3. Nowag Tract Sigler Addition; KPB File 2024-043 Peninsula Surveying, LLC / Sigler Location: East End Road Fritz Creek Area / Kachemak Bay APC

#### ITEM #3 - PRELIMINARY PLAT NOWAG TRACTS SIGLER ADDITION

KPB File No.	2024-043
Plat Committee Meeting:	May 28, 2024
Applicant / Owner:	Gray and Barbara Sigler of Homer AK
Surveyor:	Jason Schollenberg / Peninsula Land Surveys
General Location:	East End Rd Milepost 6 Kachemak Bay APC
Parent Parcel No.:	174-330-30
Legal Description:	Tract A-1 Nowag Tracts No 2 HM97-70
Assessing Use:	Residential
Zoning:	Rural Unrestricted
Water / Wastewater	onsite
Exception Request	none

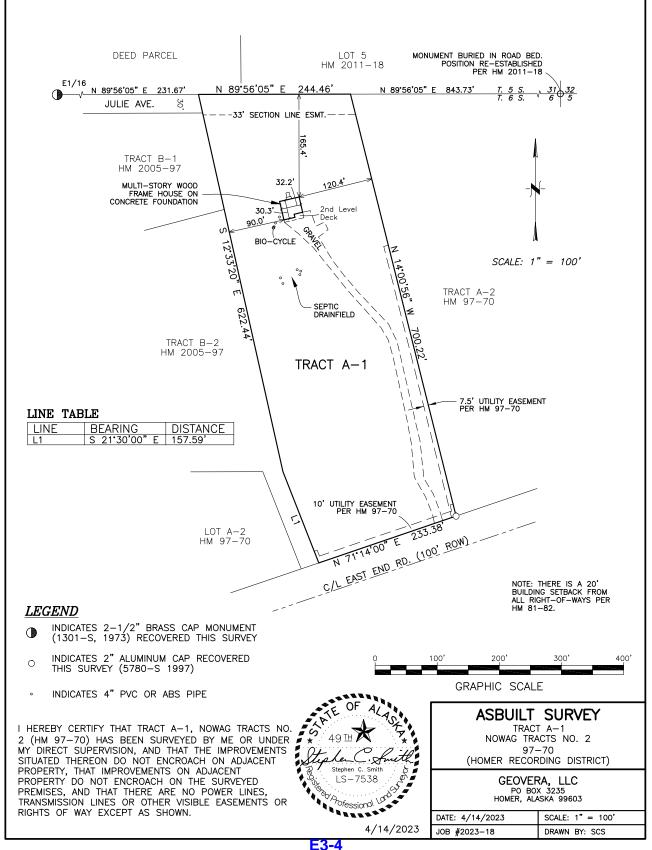
The KPB File number is 2024-043 In the legal description, Lot A-1 should be corrected to Tract A-1 According to the Assessor information, the mailing address for the owners is: PO Box 1235, Homer

The length on the cul-de-sac on the east should be 453.85'

Tract to the south should be HM 74-1199. It is also in the process of being subdivided. Prior to finalizing and recording this plat, the status of that lot should be verified for change of information. Lot A-2 to the east should be changed to Tract A-2.

The plat is split between two designated wetland types: Discharge slope and Wetland/Upland Complex. Neither are shown or indicated on the drawing and they should be.

20' setback along East End Road is per 97-70 and should be noted.

**Staff recommendation**: comply with 20.60.110. Show survey data

**Staff recommendation**: comply with 20.60.190. Add a Certificate of Acceptance with dedication to the Kenai Peninsula Borough for Johnna Circle Add the date of May 28, 2024 to the Plat Approval

20.60.200. Survey and monumentation. **Staff recommendation**: comply with 20.60.200 Show found and set monuments Show survey data Tie to GLO / BLM monuments
